Access Compliance Report

Public Rights-of-Way

(Curb Ramps)

Intersection ID: 16896	Main Street: BRIARCLIFF_PL	Cross Street: QUEENS_RD_WEST	Location: S
ADA ID: 494049DC28CB	Ramp Type: PerpDiag	Initial Pass/Fail: Fail	Overall Compliance: No
		Severity Score: 35

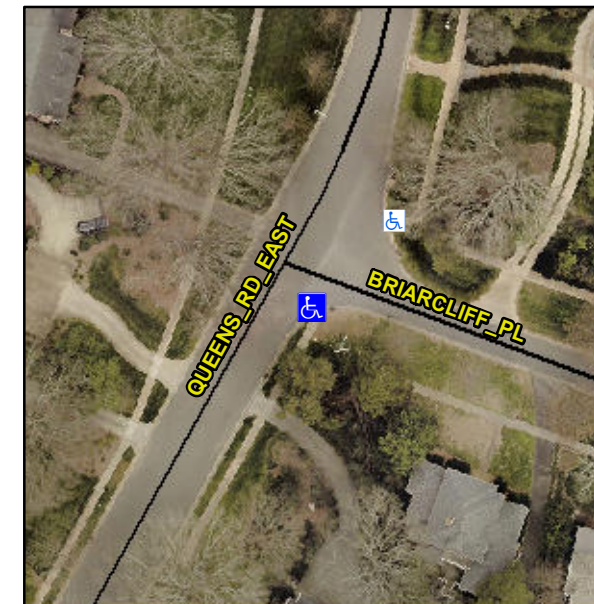
Not Found, R304.5.1, R304.2.2, R304.5.3

Compliance	Description	Data	Compliance	Description	Data
N/A	Ramp Length (in)	23.0	No	Ramp Slope (%)	12.4
No	Ramp Width (in)	45.0	No	Ramp XSlope (%)	2.3
N/A	Flare Type LT	N/A	N/A	Flare Type RT	N/A
N/A	Flare Slope LT (%)	N/A	N/A	Flare Slope RT (%)	N/A
N/A	Flare Traversable LT?	N/A	N/A	Flare Traversable RT?	N/A
N/A	Landing Length (in)	N/A	N/A	DWS Provided?	N/A
N/A	Landing Width (in)	N/A	N/A	DWS Contrast?	N/A
N/A	Landing Slope (%)	N/A	N/A	DWS Length (in)	N/A
N/A	Landing X Slope (%)	N/A	N/A	DWS Full Width?	N/A
N/A	Landing Curb? (Y/N)	N/A	N/A	DWS Offset (in)	N/A
N/A	Shared Landing?	N/A			
N/A	Gutter Ponding?	N/A	N/A	Gutter Slope (%)	N/A
N/A	Gutter Lip Ht (in)	N/A	N/A	Gutter X Slope (%)	N/A
N/A	Painted X Walk1?	No	N/A	Painted X Walk2?	No
	X Walk 1 Direction	To NE		X Walk 2 Direction	To NW
N/A	X Walk 1 Width (in)	N/A	N/A	X Walk 2 Width (in)	N/A
	X Walk 1 Slope (%)	4.7		X Walk 2 Slope (%)	7.2
	X Walk 1 X Slope (%)	4.0		X Walk 2 X Slope (%)	3.2

Remove & Replace Curb Ramp With Two New Directional Ramps or Equivalent.
